Product Change Notification

Date Issued :	December 06, 2024	PCN Number :	516309
Reason for Change :	Change to Product		
Description of Change :	This notification is to inform you that molex will be making a change to power contact terminal of the parts listed in this notice. we will change contact shape and height and please see below for more details.		
Reason for Short Notice :	Custom Products		
Assessment of Change :	Reliability Test Report/s		
Planned Implementation Date :	February 01, 2025		
Customer Sample Availability Date:	December 25, 2024		
Last date to request Samples by Customer :	December 25, 2024		
Please note if Samples are not requested as per Customer Samples Request date, it may take additional 4-6 weeks to arrange Samples.			
Traceability Code Markings / Date :	Special marking on the product or packaging

Before Picture

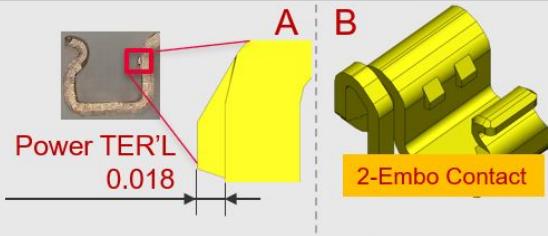
- This purpose is to change the contact shape of terminal as follows in order to improve withdrawal force.
- This change was verified to have an improvement in the withdrawal force of about 20% or more by changing contact height and shape of the terminal.

ITEM	BEFORE	AFTER
Change Points (Unit : mm)	 <p>Power TER'L 0.018</p>	 <p>Power TER'L Max. 0.025</p>
Improvement Point	<p>Withdrawal force : AVG 6.0N</p> 	<p>Withdrawal force : AVG 7.0N</p>
